MONTICELLO NUCLEAR GENERATING PLANT
DOCKET NO. 50-263

LICENSE AMENDMENT REQUEST DATED AUGUST 4, 1975

PROPOSED CHANGES TO TECHNICAL SPECIFICATIONS
APPENDIX A OF PROVISIONAL OPERATING
LICENSE NO. DPR-22

Figure 3.11.2
 F_c Ratio Versus Percent
 of Rated Core Flow

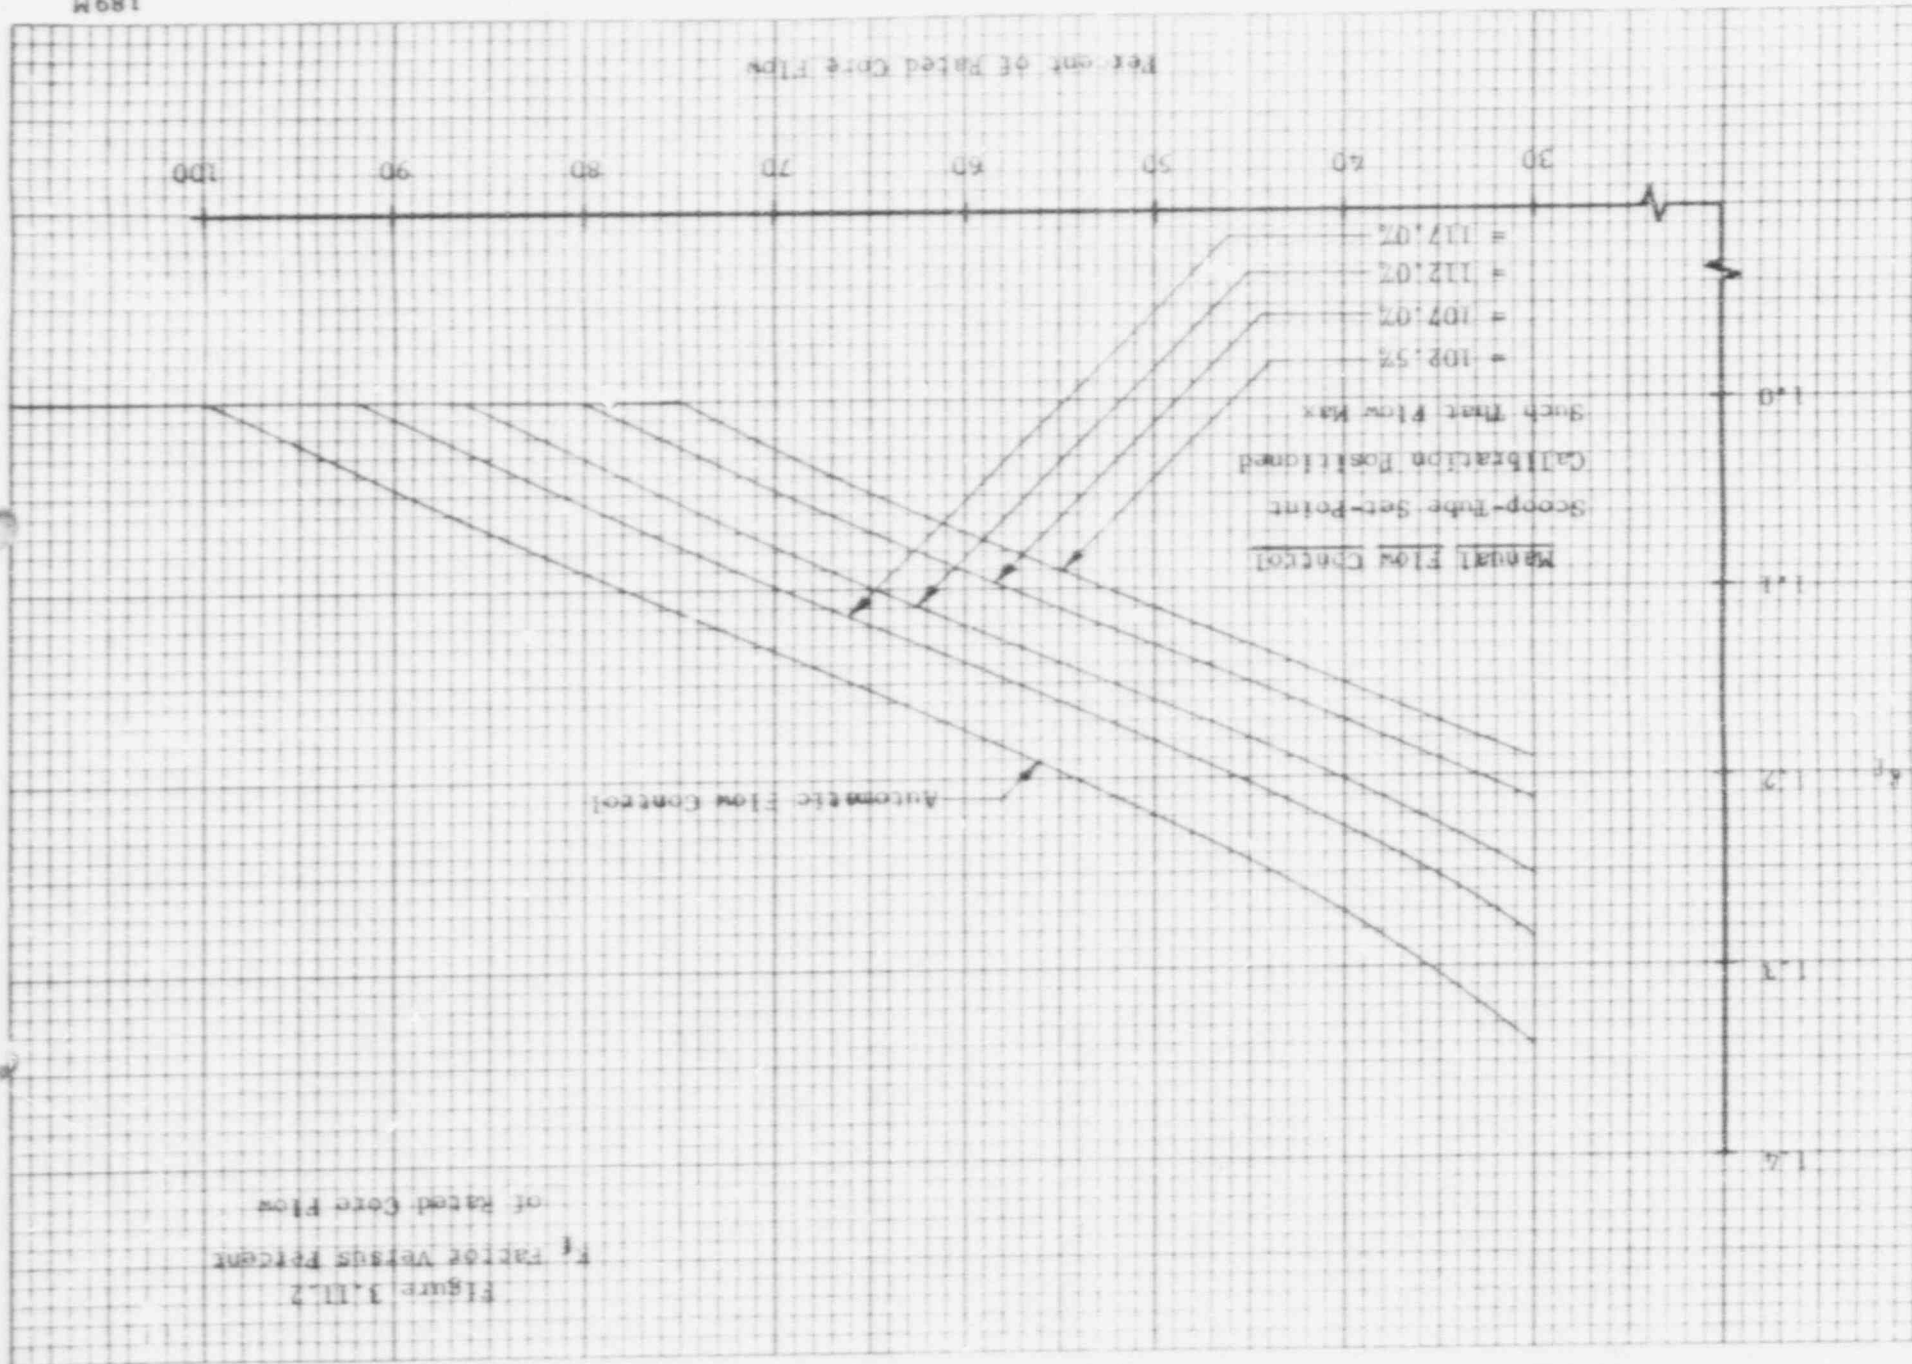
Change the page number of Figure 3.11.2 from 189K (as presented in Reference iv Exhibit B) to 189M as shown in the attached Exhibit B.

The insertion of additional pages in item 1 above requires this change to arrange figures sequentially.
